Advice & Counsel

EPA Official Responds to MP&M Column

Advanced Cyanide Destruct System Used by Midwest Plater

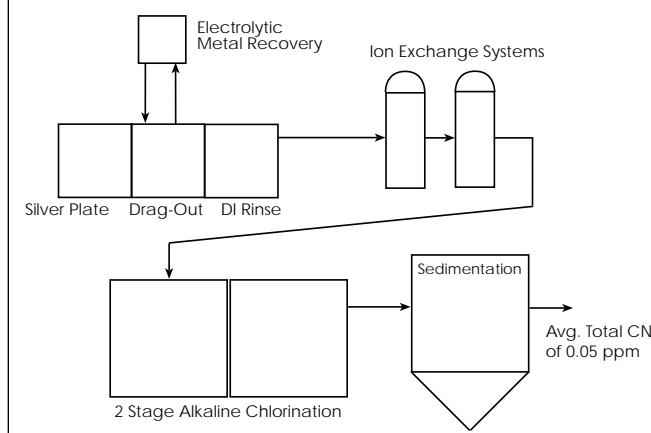
To illustrate our point further, a Wisconsin jobshop plater has gone far beyond alkaline chlorination for destruction of cyanide. A schematic of the system used by this plater is provided. This plater has systematically eliminated all unnecessary cyanide processes, including elimination of cyanide from cleaners, copper plating, and brass plating. A total reduction of cyanide usage of almost 76 percent was achieved between 1990 and the present. The remaining cyanide-based process used by this plater is silver plating. For this process, this facility has installed a drag-out rinse after plating, equipped with an electrolytic recovery cell. Following the drag-out rinse is a DI water rinse that is routed to an ion exchange system. The discharge from the ion exchange system is routed to a two-stage alkaline chlorination system, followed by sedimentation. At the end of this entire train of treatment and after commingling with non-cyanide wastewater, the discharge contains an average of 0.05 ppm based on self-compliance monitoring during 1995! From January of 1994 until the present, this plater has determined cyanide levels ranging from none detected to 0.3 mg/L.
